Eau Claire Residential High Rise
727 1st Ave SW, Calgary, AB

DP2021-3142| UDRP COMMENTS & RESPONSES

Submitted to City of Calgary Urban Design Review Panel
by Graywood Developments + IBI Group
June 2021

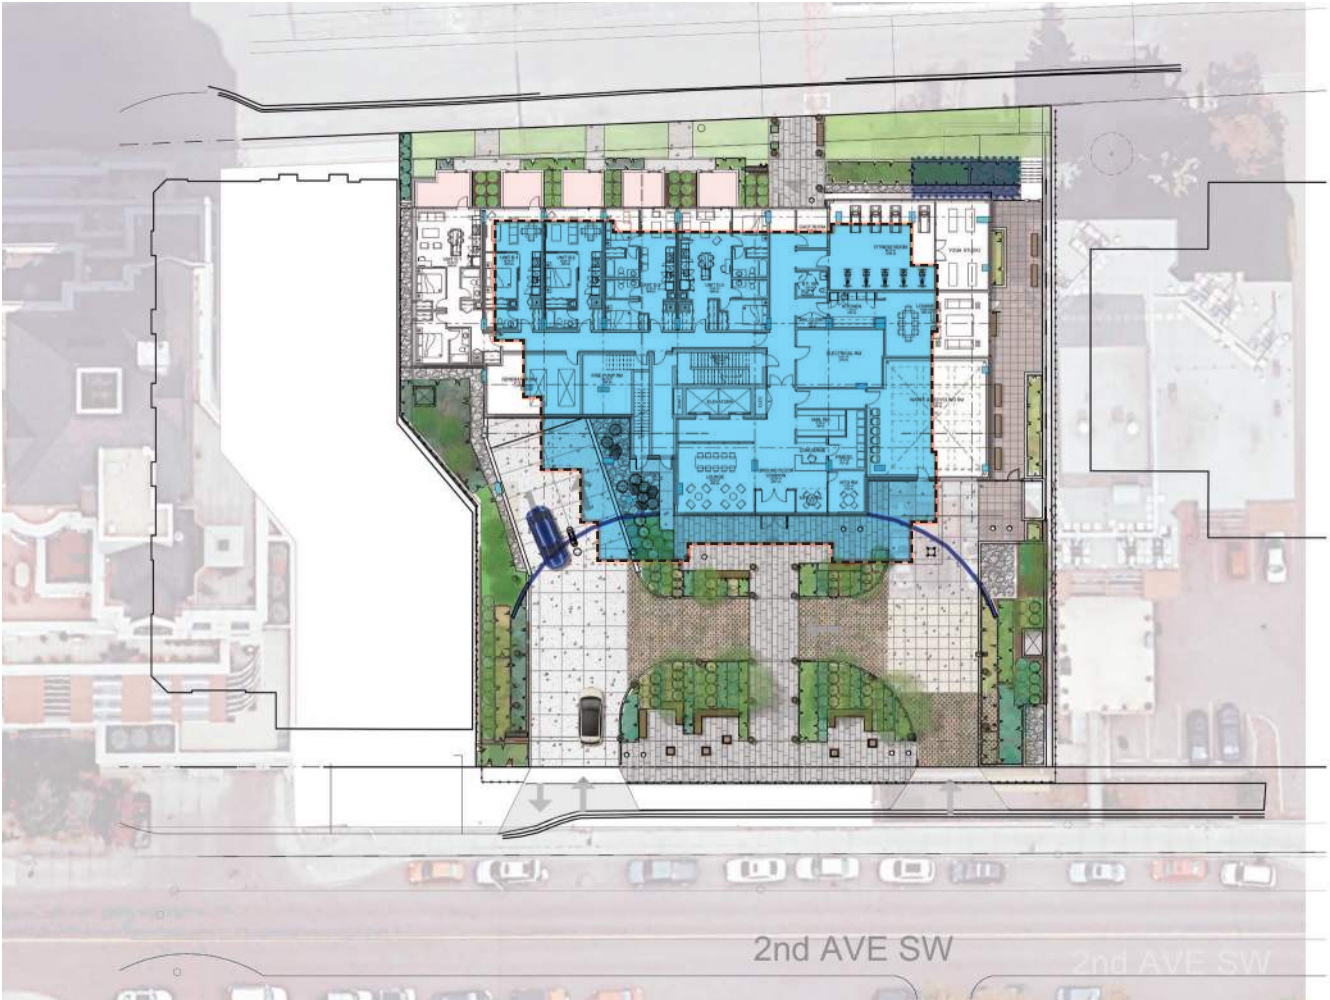
Urban Design Element	
Creativity <i>Encourage innovation; model best practices</i> <ul style="list-style-type: none">Overall project approach as it relates to original ideas or innovation	
UDRP Commentary	The project as presented is generally an acceptable response to the site. The higher quality construction materials and curved elevation facing the river valley are supported by the panel. There was no specific innovation or best practice identified in the submission.

In the redevelopment of the project we have reduced the size of the typical floor plate to allow better separation of the tower to the property lines. The concept we have developed has a level of complexity requiring creativity to achieve. There are several aspects to the site which provide opportunity and constraint. These include:

- We have two fronting streets, one which we developed as a residential pedestrian scale, the other ceremonial and entry focused. We have a people and vehicular aspects
- We have an existing neighbour with little setback and living space oriented to our site. We have oriented our suite plans to avoid overlook to and from, we have allowed and increased previous view corridors across our site.

- We have developed a strong two storey base to the tower reinforced by a dominant horizontal brow at the 3rd floor line on the north elevation. This mass is a clean face of glass with projecting balconies.
- With the reduction in the tower plate size we were able to increase the height of the building by one storey. This is beyond the recommendation in the ARP but we have dealt with it in a different way. We have developed a strong cornice line at the top of the 17th floor with the top two floors inset. There is a coloured band located on the underside of the 18th floor plate. The primarily glazed 18th floor is set back from the edge of the plate by a substantial amount so that the 18th floor plate reads more as the top of the building.
- We have introduced a curved screen wall on the south elevation to serve three purposes:

- The first to introduce a line that is approximately 2 storeys tall.
 - The second is to provide a screening device to lower the impact of the driveway entry and loading areas from the “front door”
- Thirdly to provide a soft backdrop to the park / entry setting facing 2nd Avenue
- In the development of the tower we were looking for a simpler architecture with specific accents. The tower is regularly designed with proud corners and recessed central massing. We have exposed the circular column structure vertically through the height of the building on the corners and we have exposed circular columns at the ground and second floors in the base development and at the sub-penthouse floor to emphasize the top.
 - We have organized gold accent bands at various levels of the balcony edges to highlight and break up the simple tower massing.

BUILDING OVERLAY COMPARISON

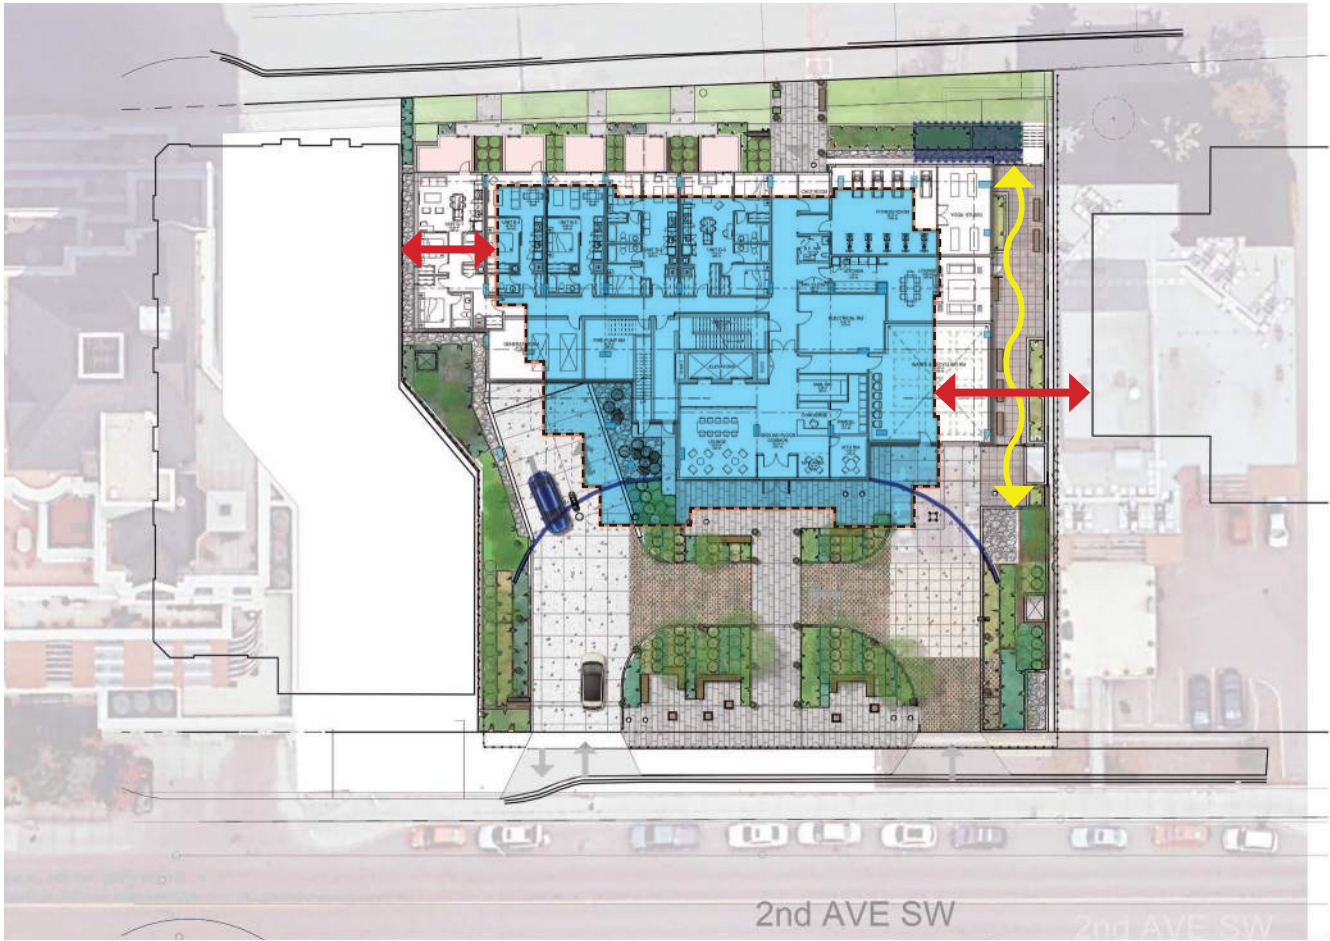
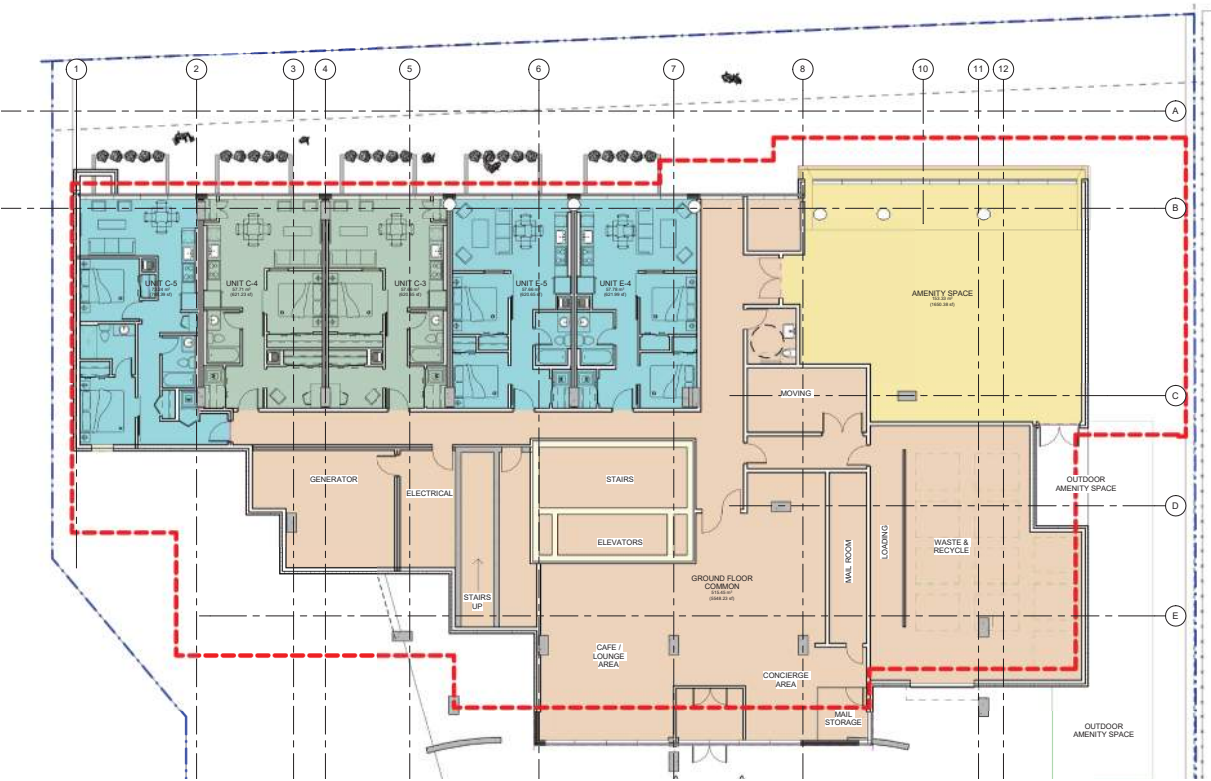
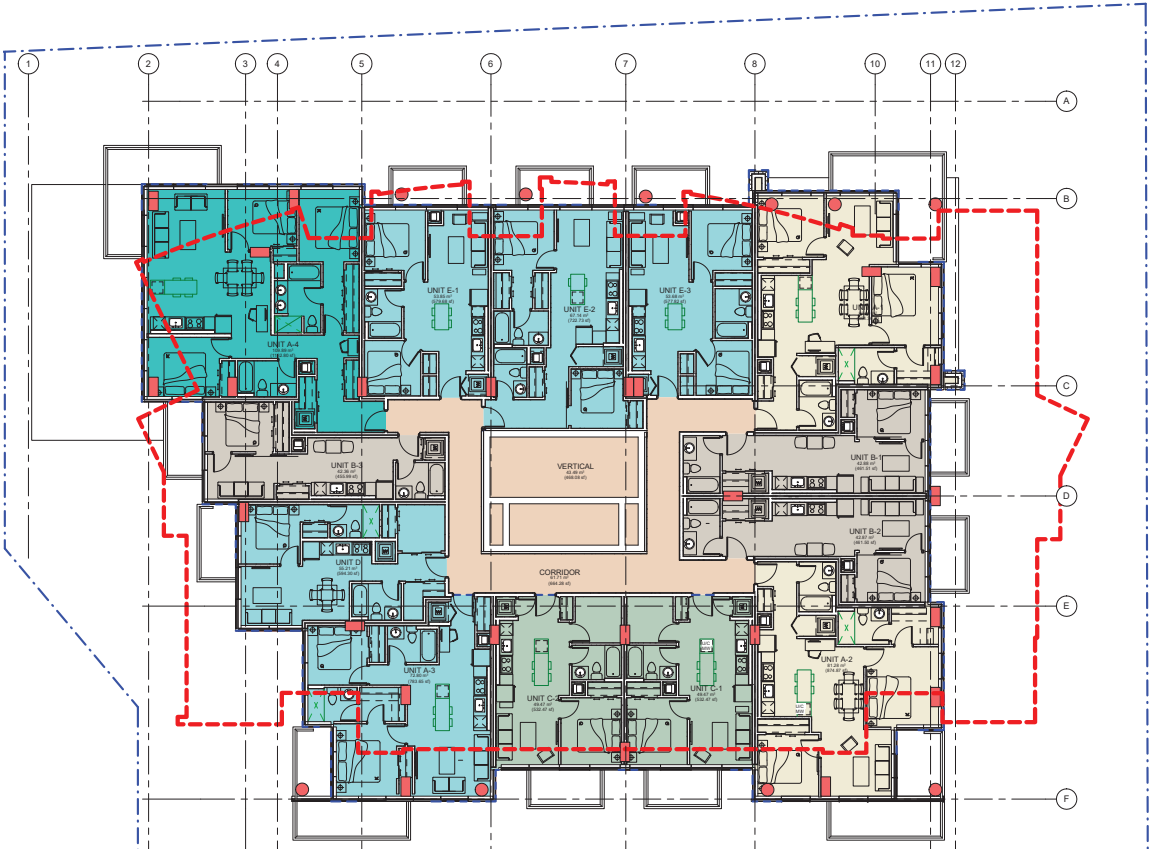
Context Optimize built form with respect to mass and spacing of buildings, placement on site, response to adjacent uses, heights and densities <ul style="list-style-type: none">• Massing relationship to context, distribution on site, and orientation to street edges• Shade impact on public realm and adjacent sites	
UDRP Commentary	The building extends almost to the site edges at the West/East, optically crowding the existing neighbouring buildings. The resolution of the side elevations with respect to views, windows, etc should be further studied by the Applicant. The building setback and associated plaza facing 2 nd Avenue seemed reasonable with the improved landscape design. Details showing how the 'pocket park' might be used by the public (seating for example) would be important to develop.
Applicant Response	The site has numerous opportunities and constraints. In the concept stage of design we reviewed several options to determine the best use for the site. Please see attached appendix as a summary for the work we developed to land on the current concept. Please refer to our "view" plan on page 21 of the Building Options Appendix.

We have reconfigured the base two floors of the project. We have retained the west elevation tight to the two storey vertical blank wall of the neighbouring building. We have provided a 4.926 m setback between the east elevation and the east property line. This area will be used as an outdoor space for the adjacent amenity area. It also provides a view through and daylight access vs

closing off permeability from 1st to 2nd Avenue. The pocket park has been developed with an inviting open area to the public with seating options provided. The public park is devived from private property through a "gateway" signified use of a change in surface materials and taller pedestal lighting. We have also developed a lush, permeable landscape buffer of lower shrubs and aspen rows.

RESIDENT VIEWS & OVERLOOK ANALYSIS

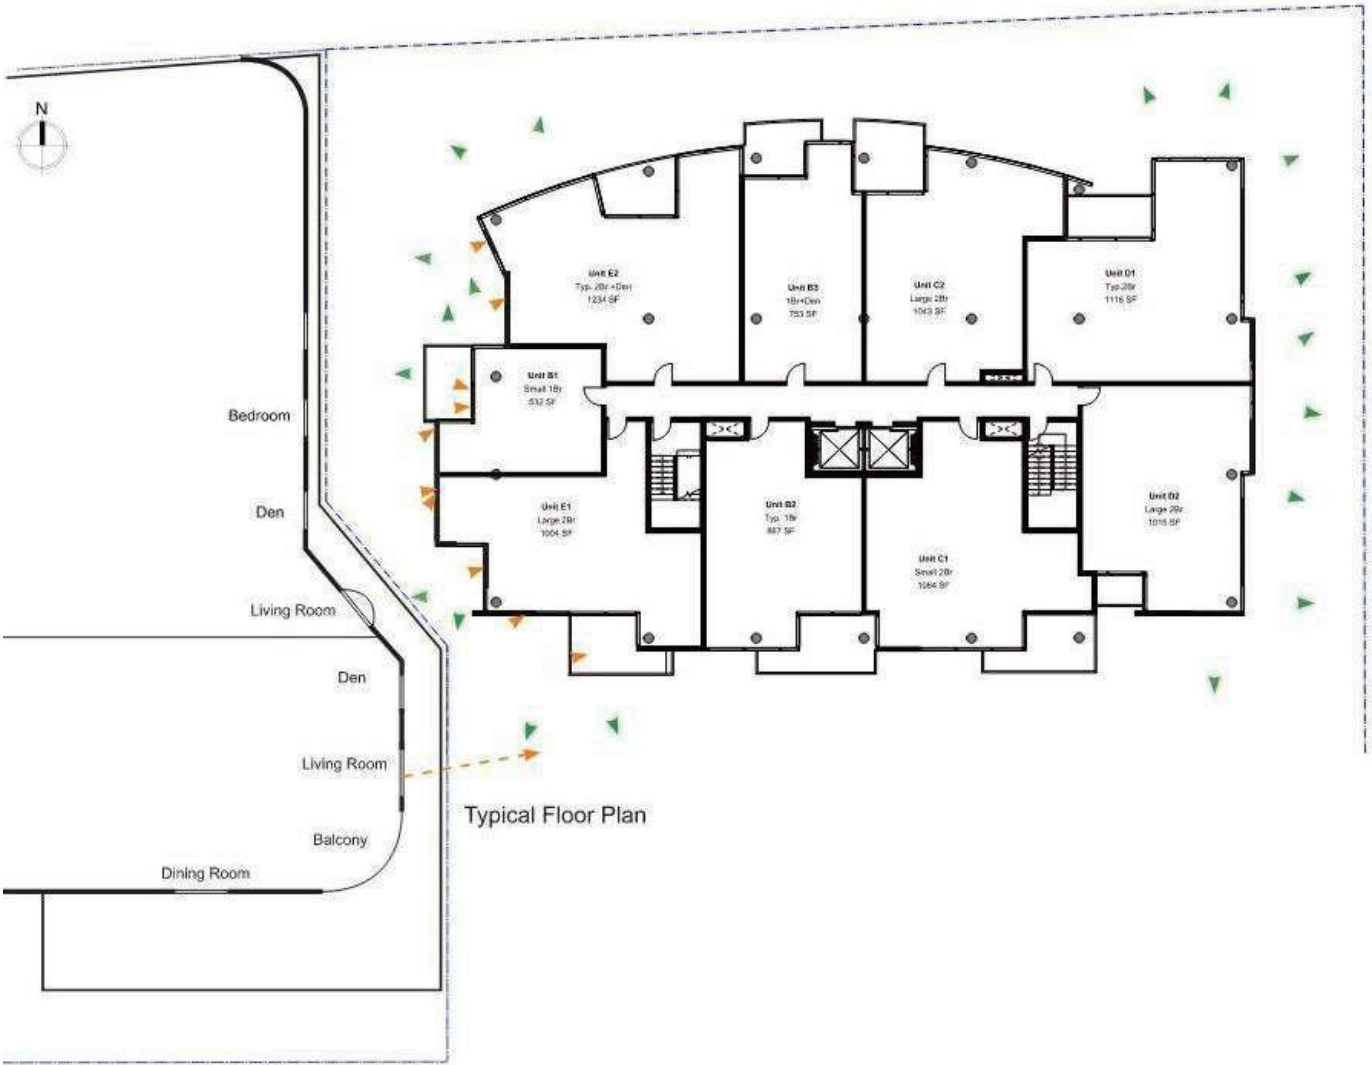
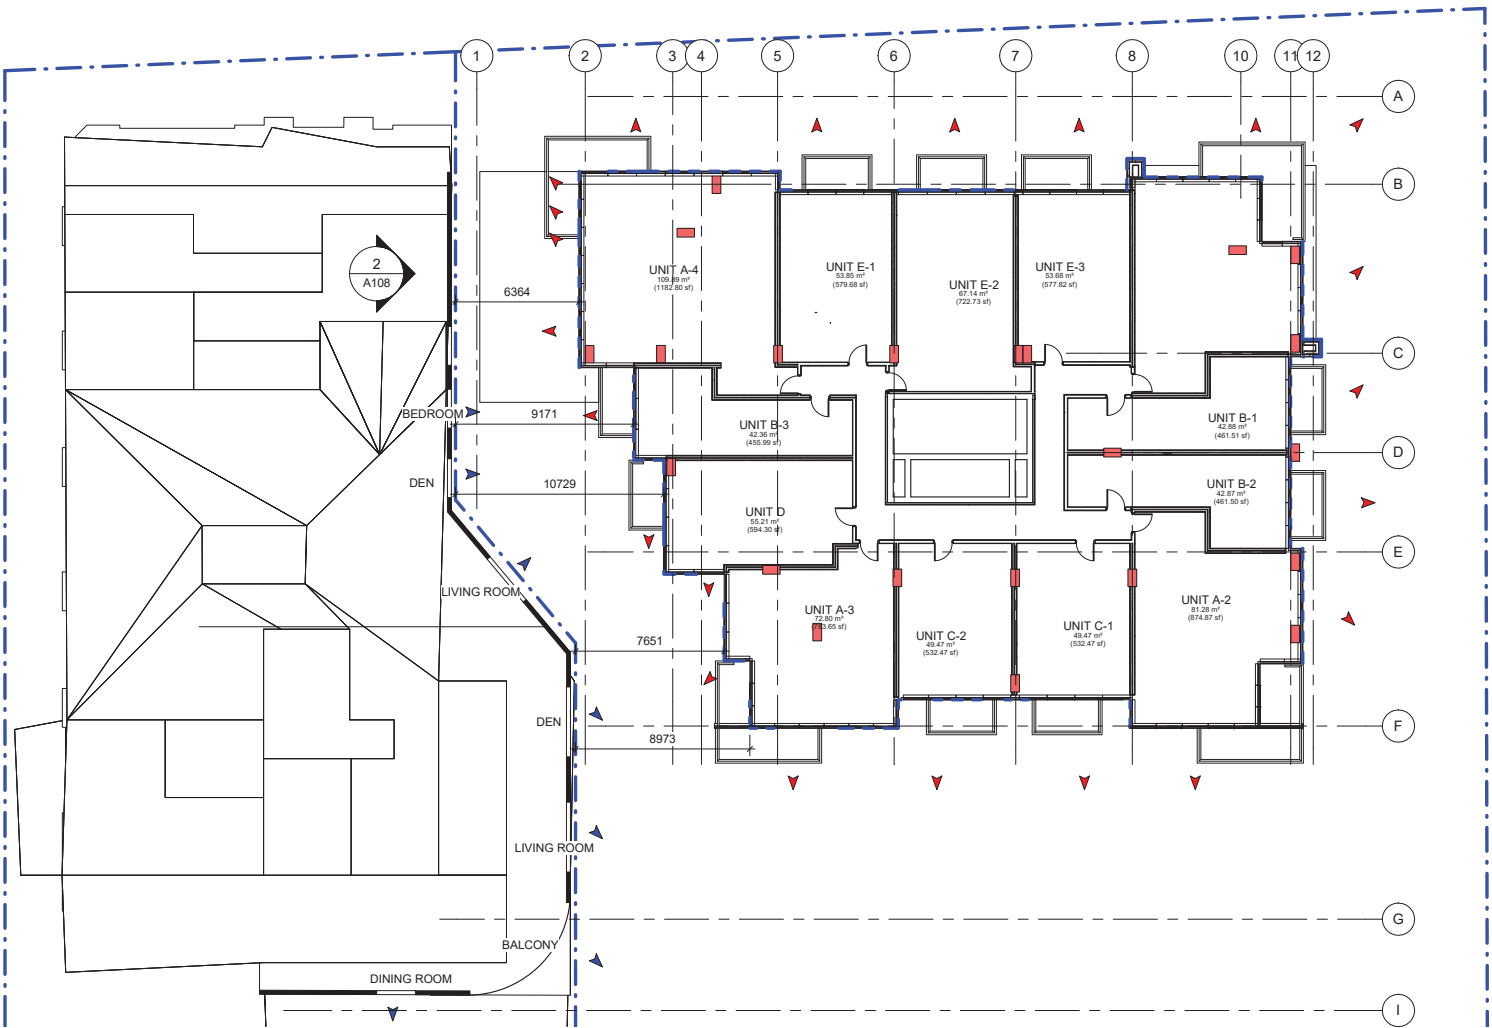
Context Optimize built form with respect to mass and spacing of buildings, placement on site, response to adjacent uses, heights and densities <ul style="list-style-type: none">• Massing relationship to context, distribution on site, and orientation to street edges• Shade impact on public realm and adjacent sites	
UDRP Commentary	The building extends almost to the site edges at the West/East, optically crowding the existing neighbouring buildings. The resolution of the side elevations with respect to views, windows, etc should be further studied by the Applicant. The building setback and associated plaza facing 2 nd Avenue seemed reasonable with the improved landscape design. Details showing how the 'pocket park' might be used by the public (seating for example) would be important to develop.
